CITY OF WESTMINSTER			
PLANNING APPLICATIONS COMMITTEE	Date 3 February 2015	Classification For General Release	
Report of Operational Director Development Planning		Wards involved West End	
Subject of Report	23 Great Windmill Street, London, W1D 7LF		
Proposal	Installation of a raised deck, access stairs and play structures within the existing playground between the school and Nos. 24-25 Great Windmill Street. Construction of new boundary treatment on the Great Windmill Street boundary in the form of two storey 'play cubes'.		
Agent	Jane's Pond Ltd		
On behalf of	Soho Parish School		
Registered Number	14/08330/FULL	TP / PP No	TP/1920
Date of Application	11.08.2014	Date amended/ completed	28.08.2014
Category of Application	Minor		
Historic Building Grade	Unlisted		
Conservation Area	Soho		
Development Plan Context - London Plan July 2011 - Westminster's City Plan: Strategic Policies 2013 - Unitary Development Plan (UDP) January 2007	Within London Plan Central Activities Zone Within Central Activities Zone

23 GREAT WINDMILL STREET, W1

Proposal: Installation of a raised deck, access stairs and play structures within the existing playground between the school and 24/25 Great Windmill

Proposed steps /
platform elevations

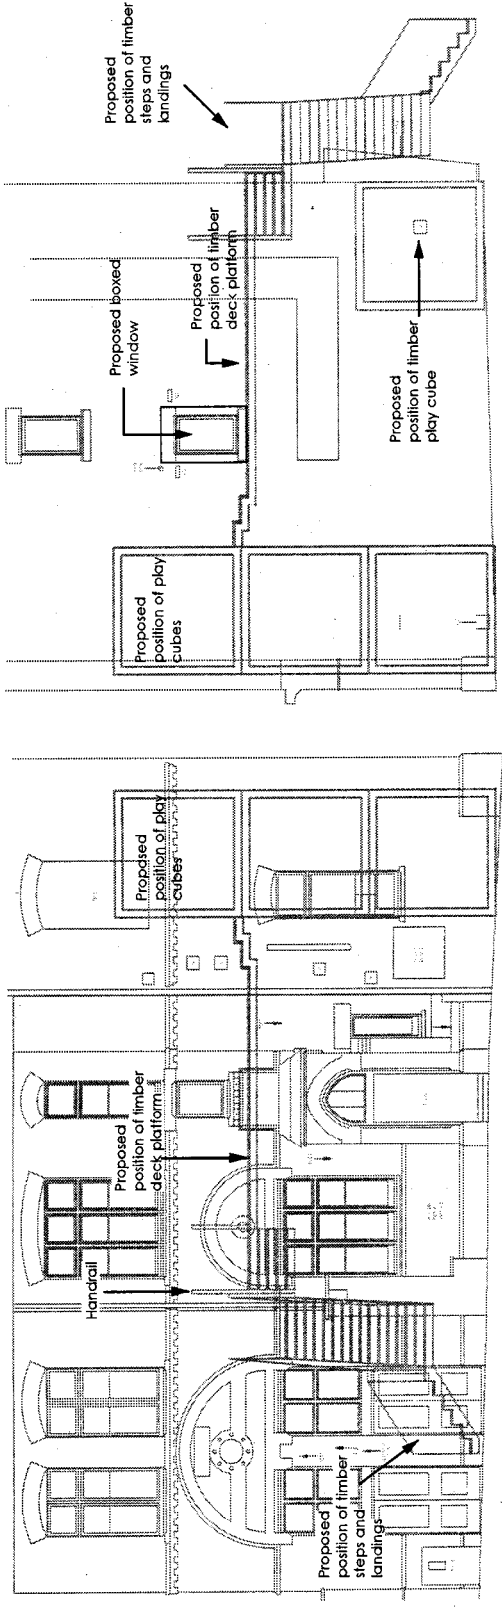
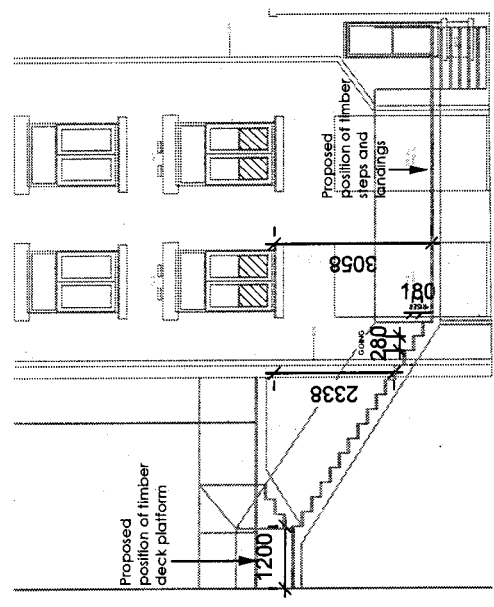
It is considered that the re-positioned staircase to the rear is acceptable. The landing is a sufficient distance away from the bedroom windows and the main stair is located closer to the school building rather than the residential building. The first floor platform is shown to extend close to a bathroom window at first floor level. The applicant has shown a 'light box' to surround and enclose this window. This would be 2m high and cover the whole of the window. However, this is not considered acceptable; the window is the only source of ventilation and the occupants of this flat should have the flexibility to open their window. It is considered that this can be addressed via an amending condition; a screen around the window is recommended. This should be at least 1.5m away and at least 2m high. This will allow the occupants to open the window and prevent children from getting too close to the window. The objections received from the flats on the upper floors on the grounds of loss of privacy are not considered sustainable due to the position of the platform at first floor level.

The proposed drawings show that the lower part of the residential windows within Nos.24-25 at first floor level will be obscurely glazed. This is not considered appropriate and an amending condition requiring the removal of obscure glazing is recommended.

- the installation of a screen/cut out around the first floor bathroom window to be 1.5m away from the window and at least 2m high.
- the removal of the obscure glazing from the lower section of the residential windows at first floor level.

Proposed street elevation

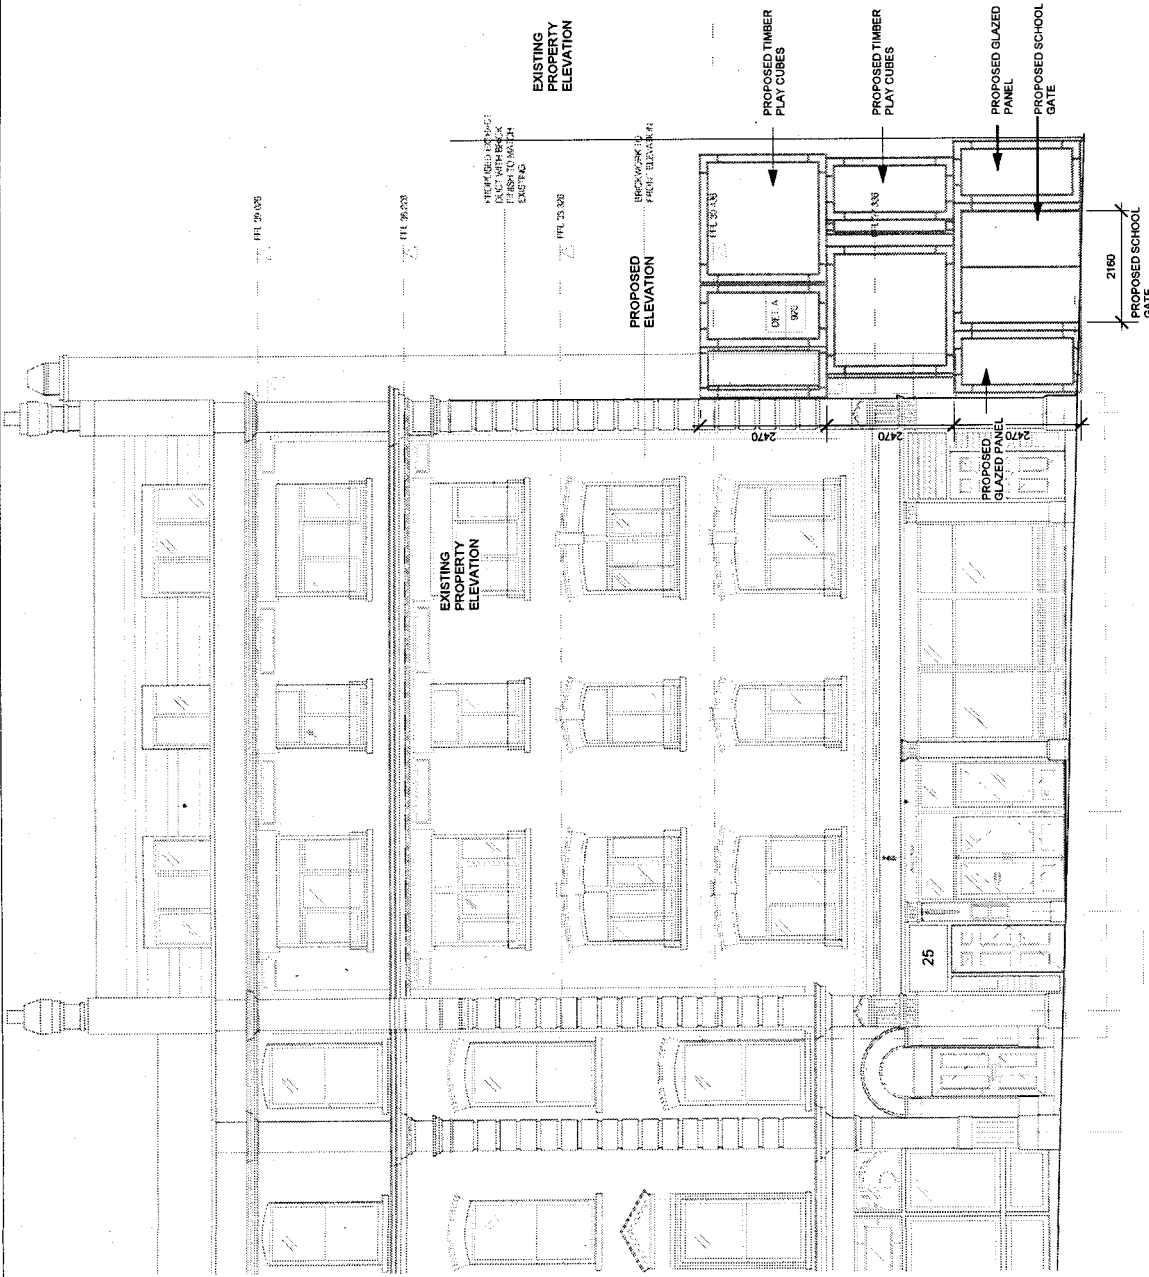
Objections have been received on the grounds that the new entrance gates will not be as secure as the existing gates and unauthorised access may be gained to the residential flats on the upper floors. The new entrance/facade on Great Windmill Street will be constructed of timber and glass, and will be taller than the existing gates. It is considered that due to the increased height, unauthorised access will be minimised.

The Great Windmill Street frontage of the structures
